Prairie Island Nuclear Generating Plant, Units 1 and 2
Docket Nos. 50-282 and 50-306
Renewed Facility Operating License Nos. DPR-42 and DPR-60

Prairie Island Nuclear Generating Plant, Units 1 and 2 License Amendment Request:
Revision to Emergency Plan Staff Augmentation Response Times

**LICENSE AMENDMENT REQUEST:
REVISION TO EMERGENCY PLAN STAFF AUGMENTATION RESPONSE TIMES**

Figure 1 Prairie Island Plant Emergency Organization

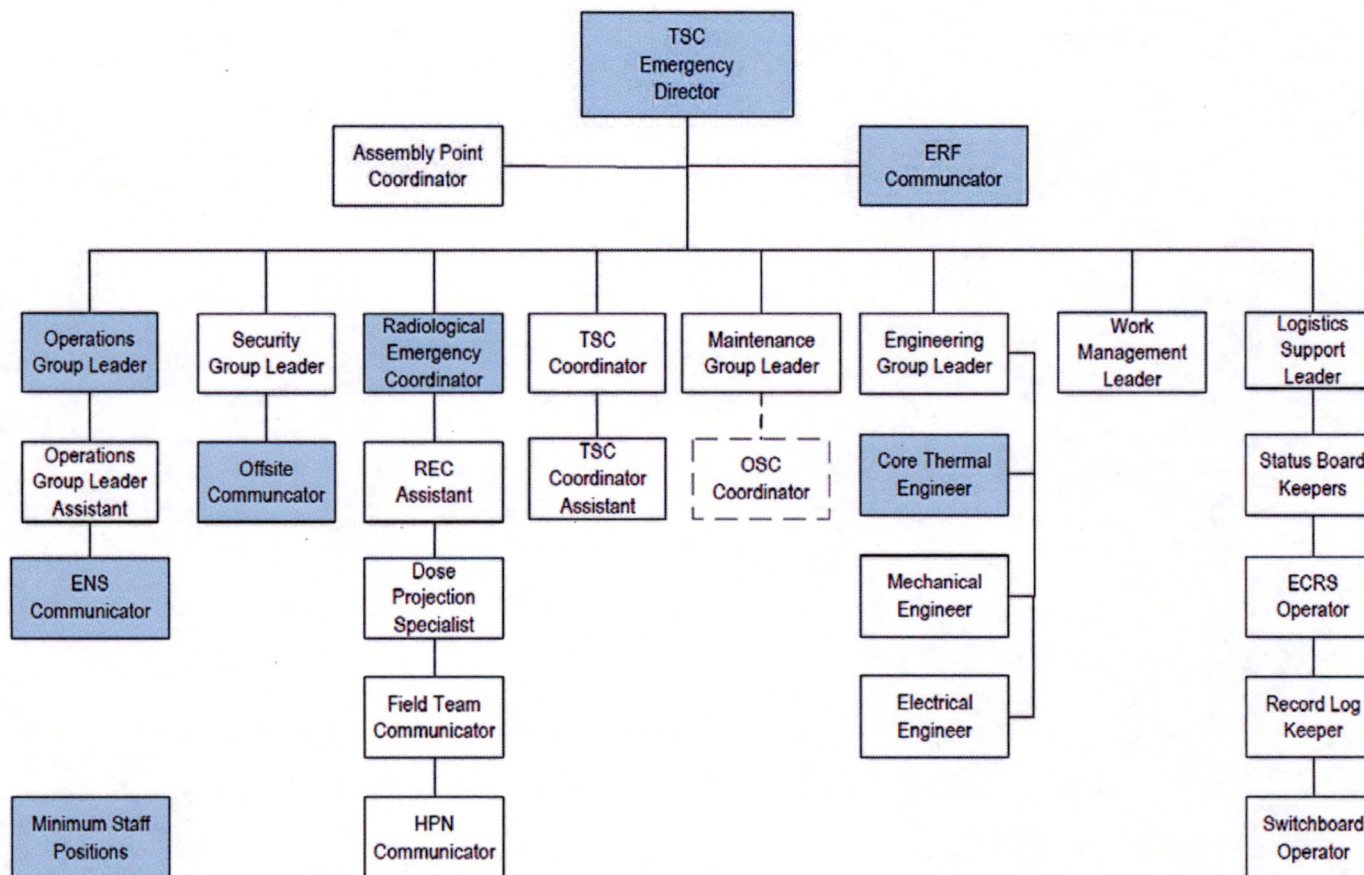
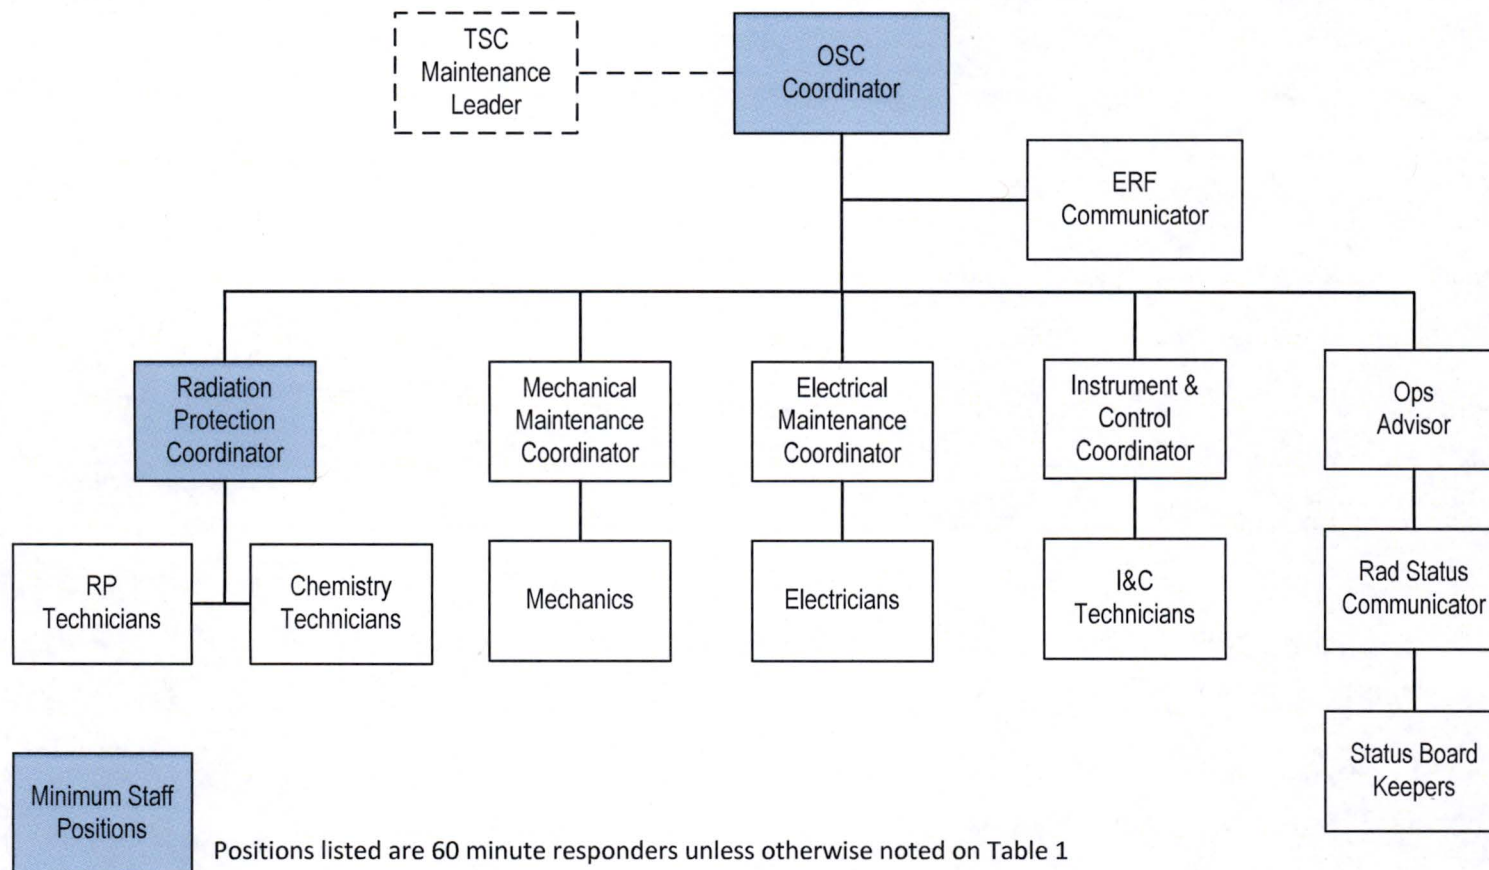
- f. Figure 1, "Prairie Island Plant Emergency Organization," was revised to reflect TSC and OSC positions including identification of positions required for facility activation.

Superseded entirely.
See revised Figure 1
on next 2 pages

Positions listed are 60 minute responders

The proposed revision to PINGP E-Plan, Figure 1, identifies the following minimum staff positions in the TSC needed to support activation of that facility within 60 minutes of an Alert or higher classification:

The proposed revision to PINGP E-Plan, Figure 1, identifies the following minimum staff positions in the OSC needed to support activation of that facility within 60 minutes of an Alert or higher classification:

Figure 2 Prairie Island EOF Organization

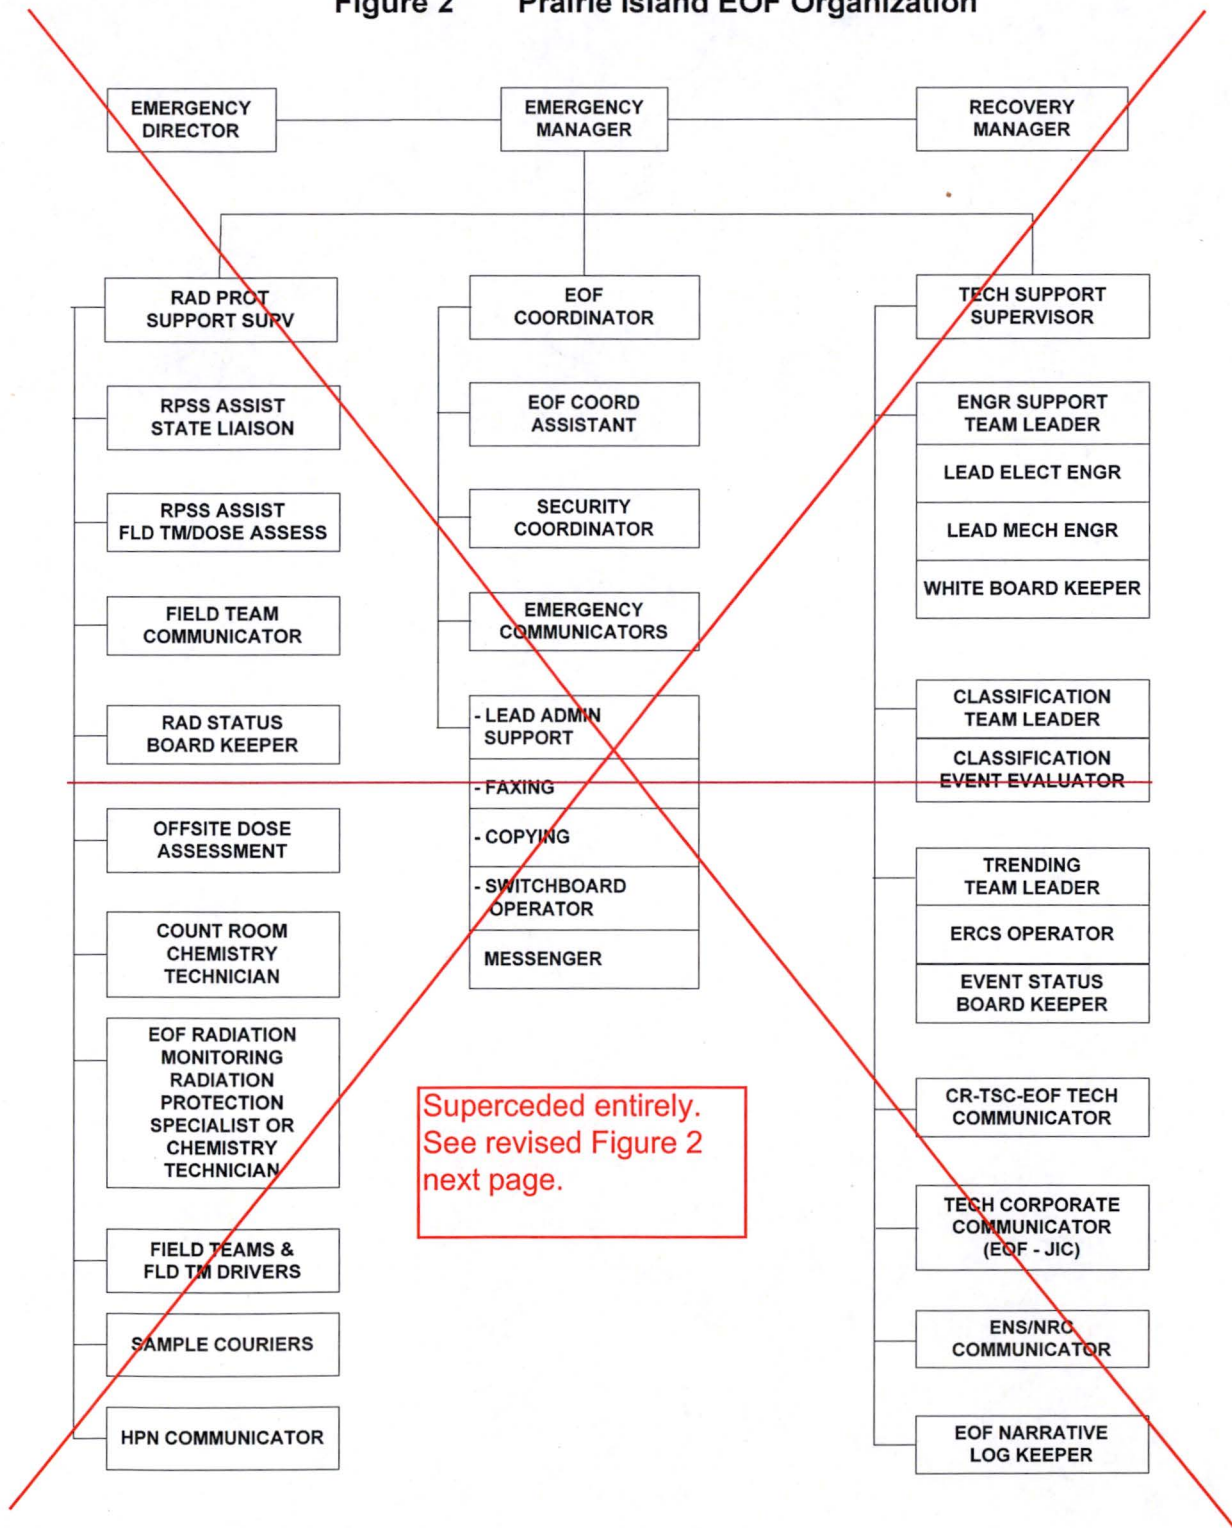
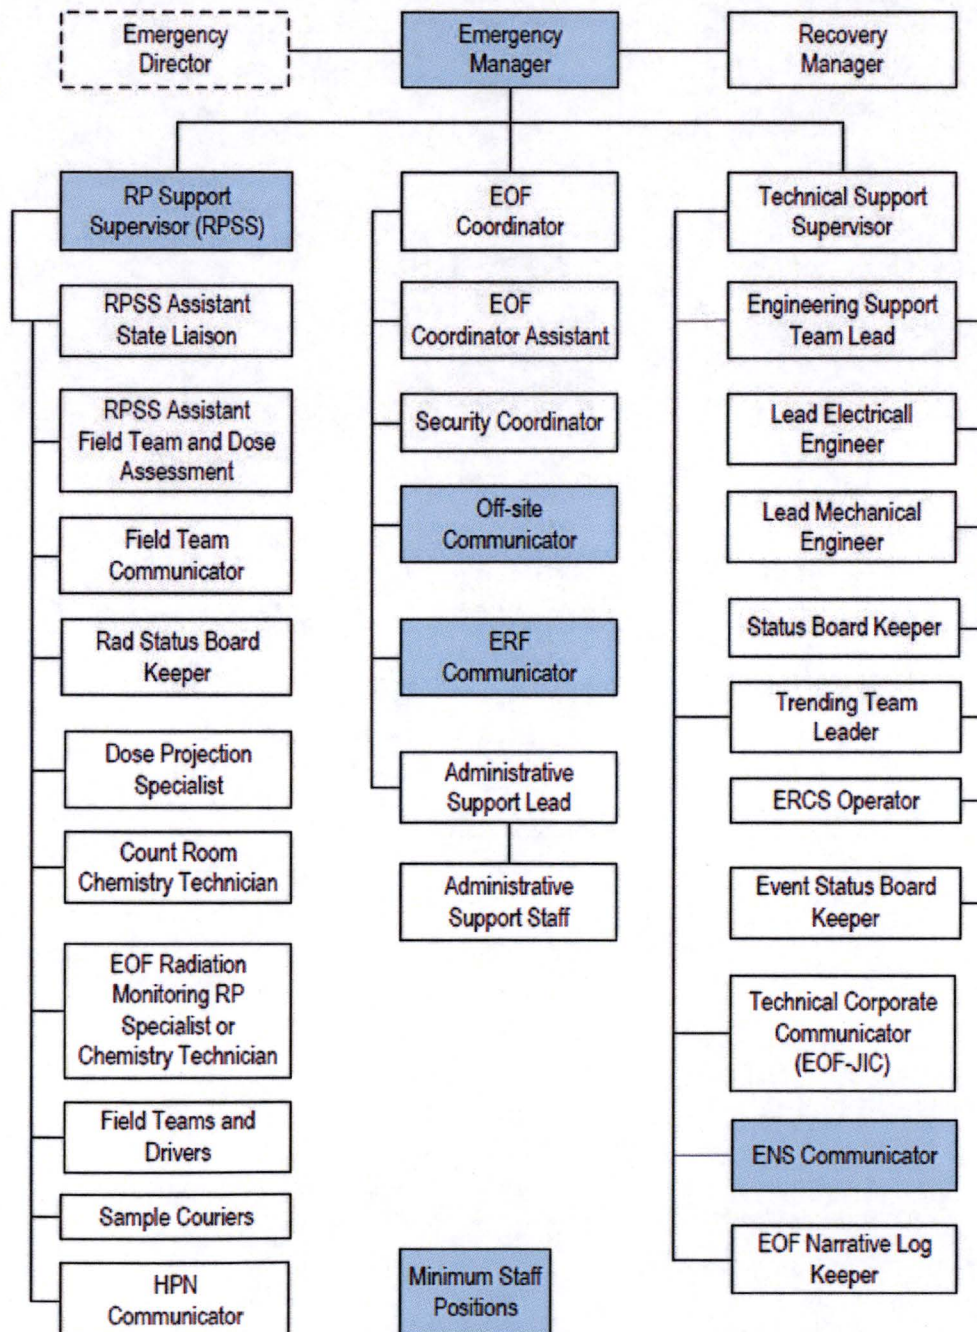
- n. Section 5.4, "EOF Organization," revised to reflect 90-minute activation time consistent with extended staff augmentation change.
- o. Figure 2, "Prairie Island EOF Organization," revised chart to reflect positions required for facility activation.

The EOF ~~will be activated~~~~should be staffed and ready to assume its emergency responsibilities from the TSC within about 1 hour~~~~90 minutes of when an Alert, Site Area Emergency or Genral Emergency is declared~~~~notification. Transfer of these responsibilities from the TSC to the EOF will be coordinated between the TSC and EOF and depend on the status of the TSC's emergency response. Actual transfer of offsite emergency response responsibilities to the EOF should occur within 60 to 90 minutes of notification.~~

The proposed revision of the PINGP Emergency Plan, Figure 2, identifies minimum staff positions in the EOF which support activation of the facility within 90 minutes of an Alert or higher classification.
